RE: Docket No: C-2011-2274074

Pursuant to the PUC Order of December 6, 2013 please find attached the required engineering report for the Oak Street crossing.

RE: Crossing Upgrade – DOT # 361-425J (Oak Street, Pittston, PA)

(View of hump from north side)

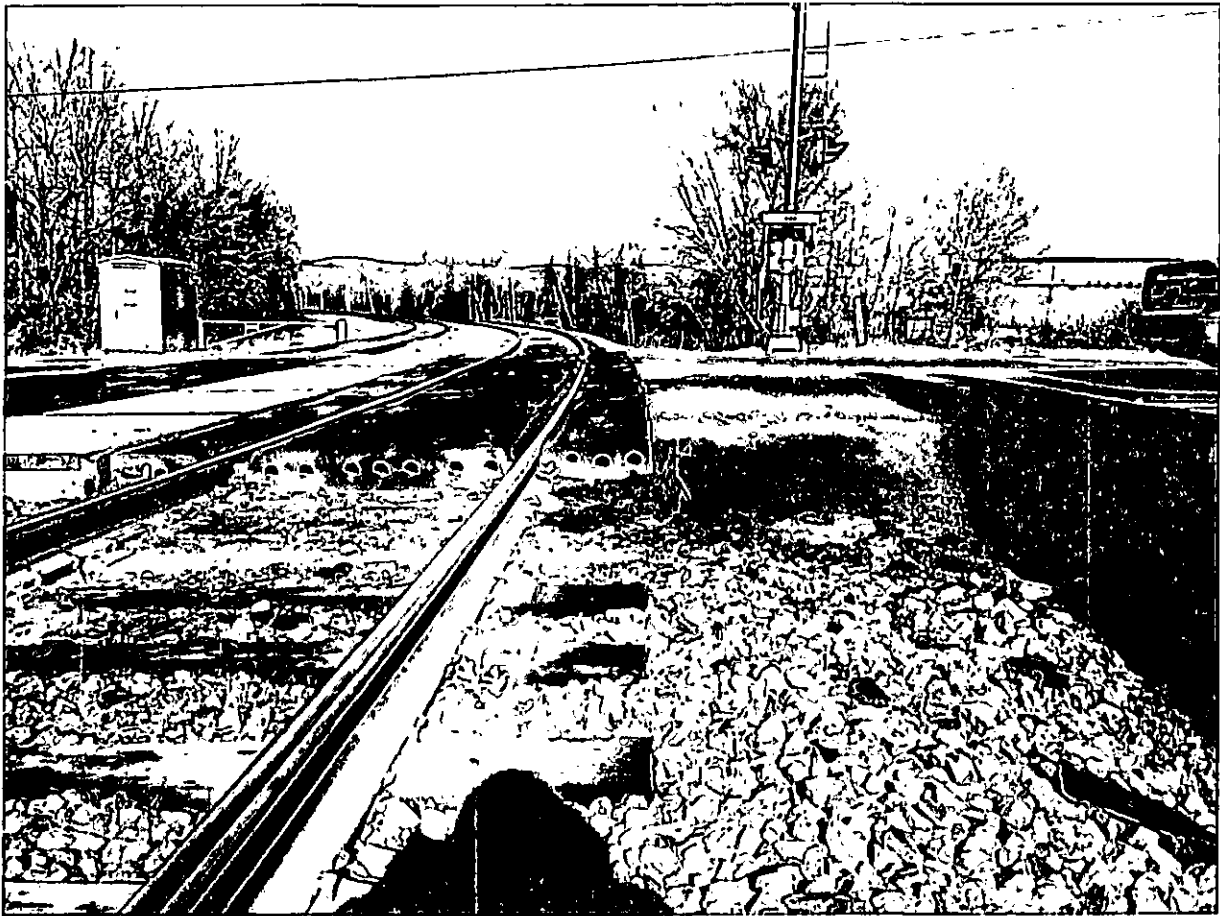
During discussions with railroad personnel, it was made known that there was potentially an issue with the roadway approaches to the crossing which may affect the life of the new crossing as well as the vehicular ride over it. During our field investigation, we identified a hump or heaving in the asphalt on the eastern (uphill) approach to the crossing.

While it is possible to replace the crossing without addressing the hump, upgrading the crossing without addressing this hump will adversely affect the overall quality and life of the crossing, as well as vehicular ride quality. It is our opinion that removing this hump restores the roadway profile to its original intent.

1. As the Railroad replaces the crossing, the road owner will cut and mill the asphalt over the entire roadway width for a distance of approximately 10 feet from the edge of the crossing panels and repave the area providing a smooth transition to the crossing.

2. The Railroad extend the cut line beyond the normal 2 feet required to install the panels to include the asphalt area for a distance of approximately 10 feet from the edge of the crossing panels and repave the area providing a smooth transition to the crossing.
